# CONSERVATION OF CHINTAMANI MANTAPA AND FORT WALL AT SNANAGHATTA AT ANEGUNDI VILLAGE GANGAVATHI (TALUK) KOPPALA (DISTRICT)

Figure 7: Present condition of the steps. The approach needs to be reconstructed.

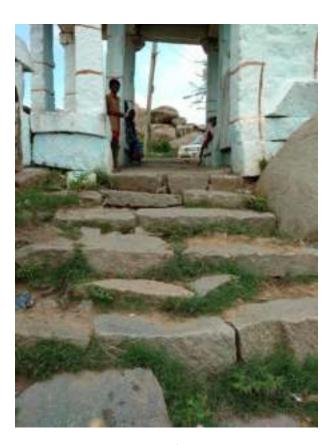
2<sup>nd</sup> Mantapa: The paint needs to be removed. The flooring needs to be levelled. The approach needs to be reconstructed to allow easy access.

Figure 9: River front facade of the fort wall - the facade is in a good condition - minimal restoration required.

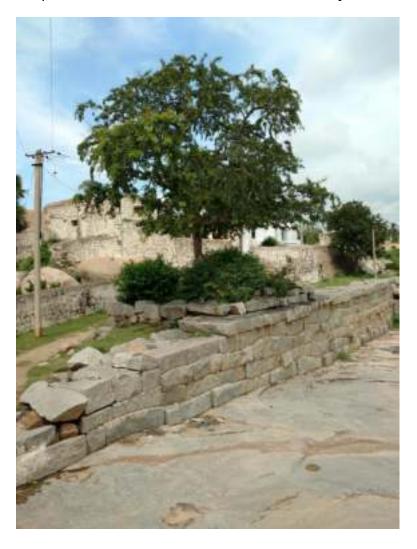
Comments: The numbering to be done with non-abrasive water soluble paint. Avoid numbering that destroys the sanctity of the structure (see figure 4). The fort wall facing the river (river front façade of the fort wall) is in a better condition than the inner façade facing the path. Minimal restoration of the river front façade is sufficient.

Figure 12: Steps need to be reinstalled.

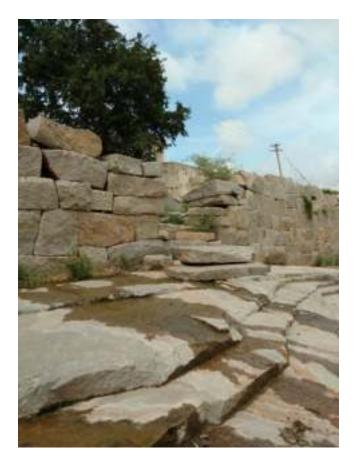
Comments: Ancient stones to be reused. The steps need to be restored to allow easy accessibility.

Figure 16: Water tank and steps to be removed.

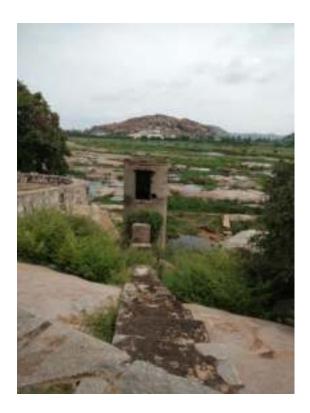
- 3. Additional lighting will help in maintaining the spaces.
- 4. The water tank which is not in use and the concrete steps to be removed as it is detrimental to the historic setting.

Figure 18: Approach to be levelled with compacted earth.

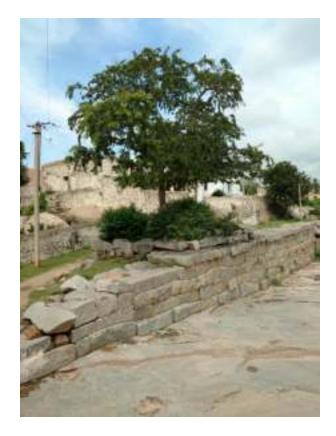
5. The outside courtyard at the entrance of the temple and the approach to temple should be levelled with compacted earth. PCC should be avoided as it is detrimental to the landscape setting.
